Development Variance Permit Information Package

File Number: 3090-20/20200042

Variance Requested: That the minimum required elevation be reduced from 3 m (9.84 ft.) to 1.5 m (4.92 ft.) above the natural boundary of Canim Lake to allow construction of a single family dwelling.

Appendix B: SPECIFIC MAP

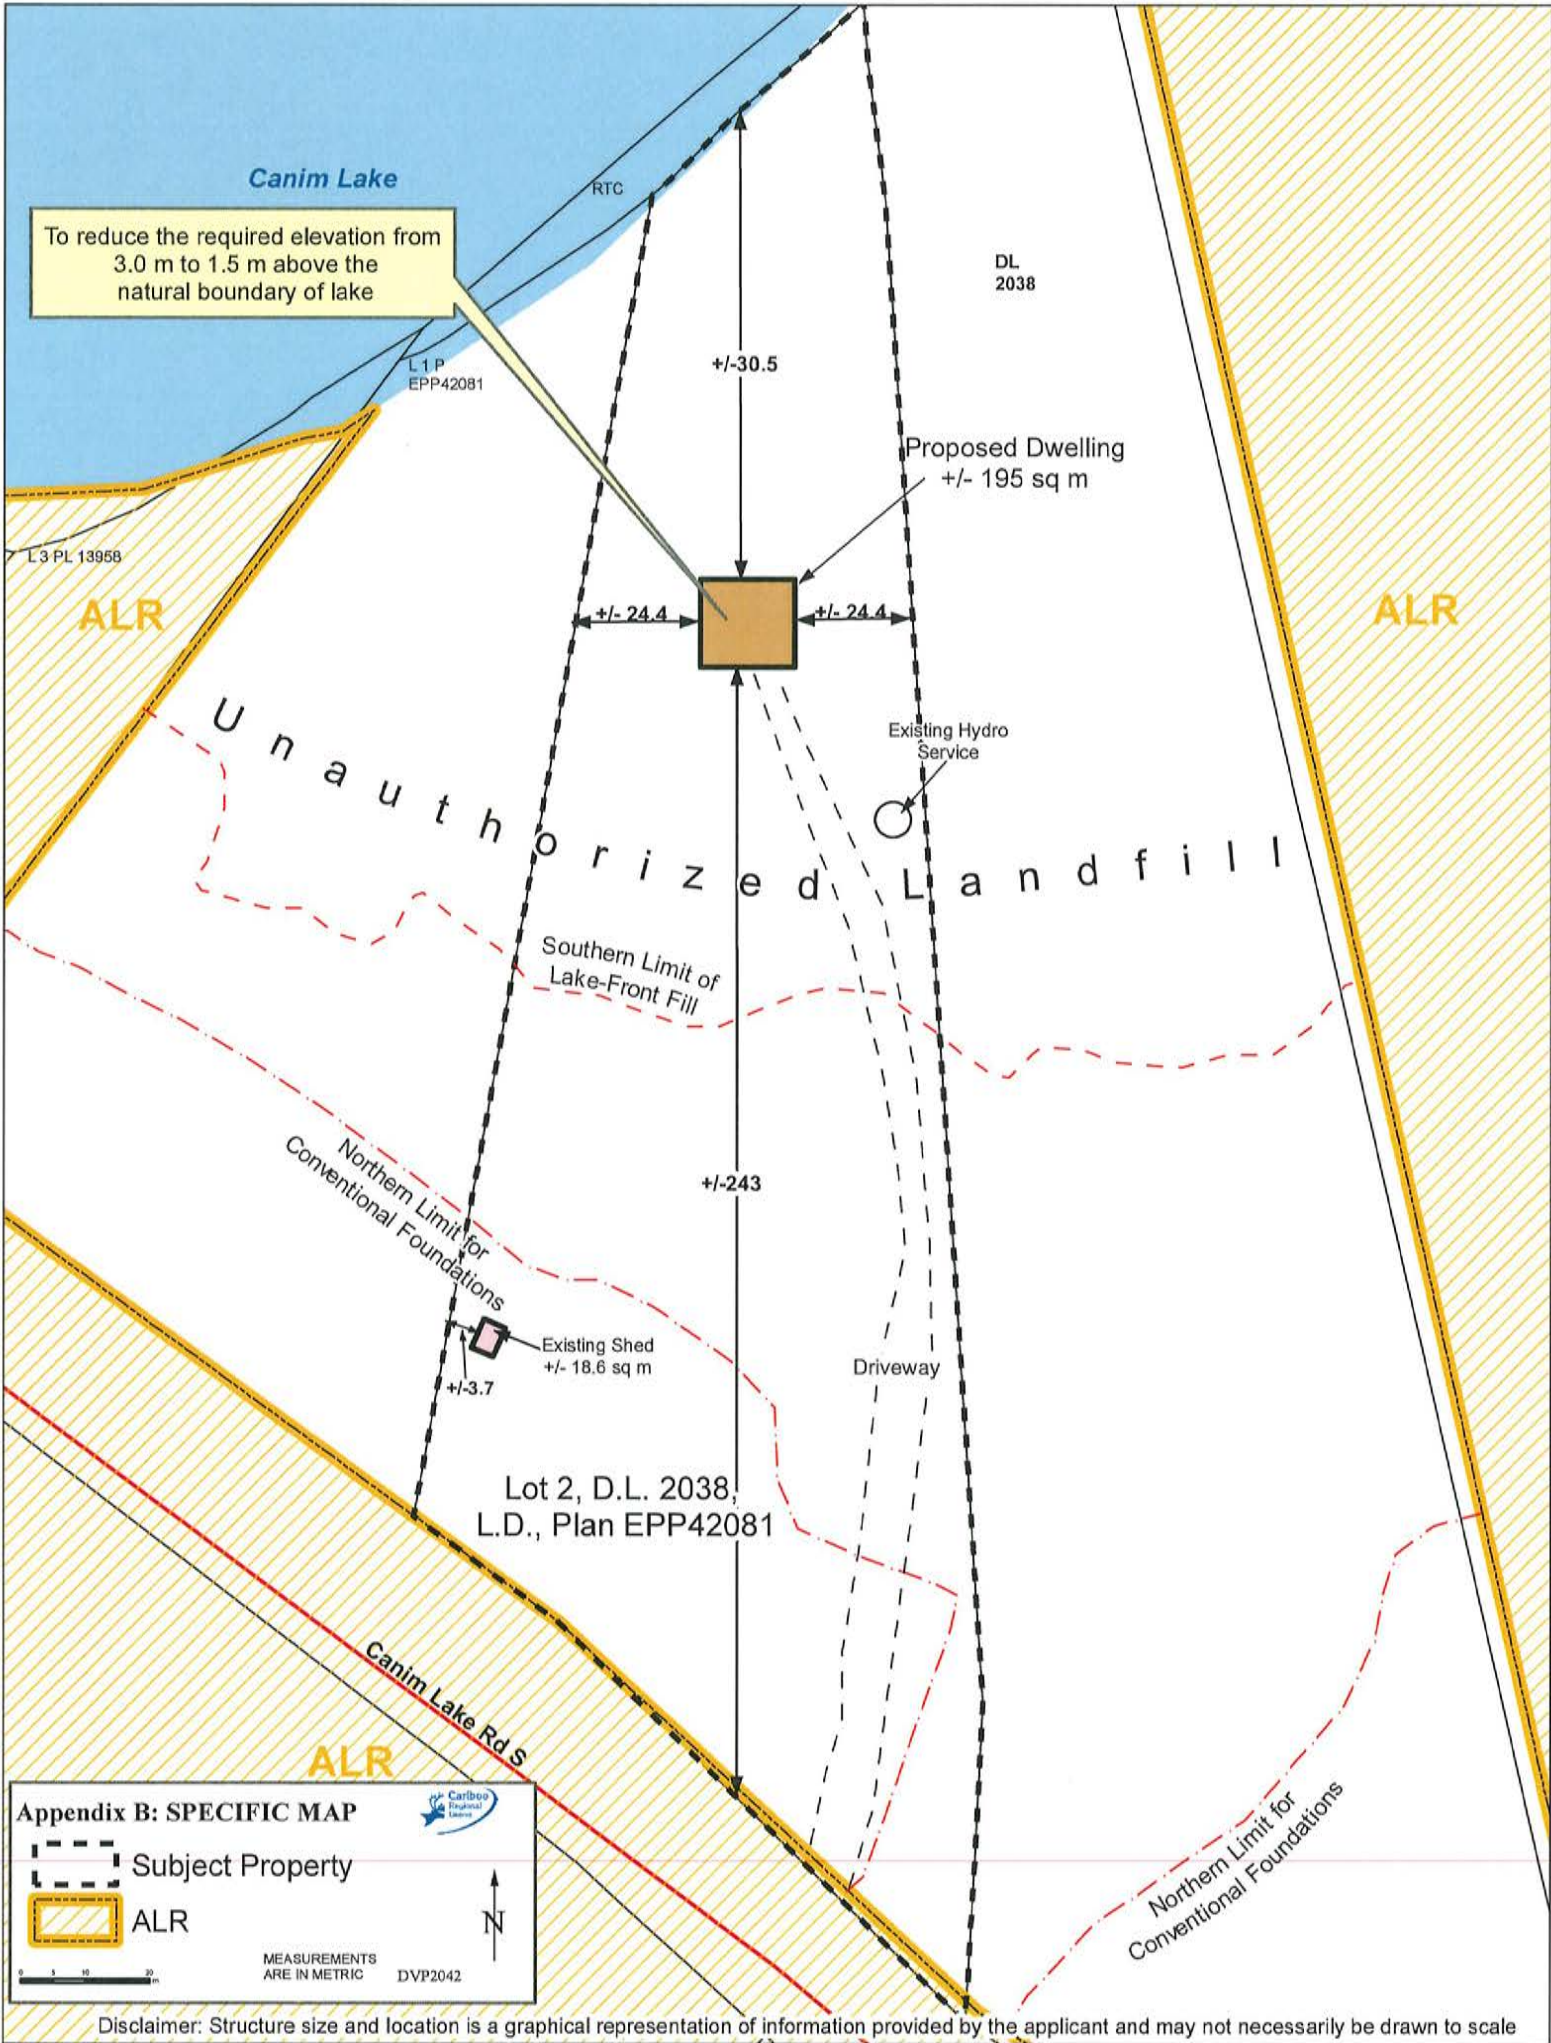
As there are other higher elevation areas on-site that are suitable for residential construction, planning staff does not support the proposal to reduce the required elevation from 3 m (9.84 ft.) to 1.5 m (4.92 ft.). The Advisory Planning Committee (APC) is also not supportive of the proposed variance as there is clear evidence of flooding in the area with neighboring properties being partially underwater due to the recent floods.

That the application for a Development Variance Permit pertaining to Lot 2, District Lot 2038, Lillooet District, Plan EPP42081 to vary the minimum required elevation above the natural boundary of Canim Lake from 3m (9.84 ft.) to 1.5m (4.92 ft.) be rejected because there are other suitable construction areas on the subject property with higher elevation.
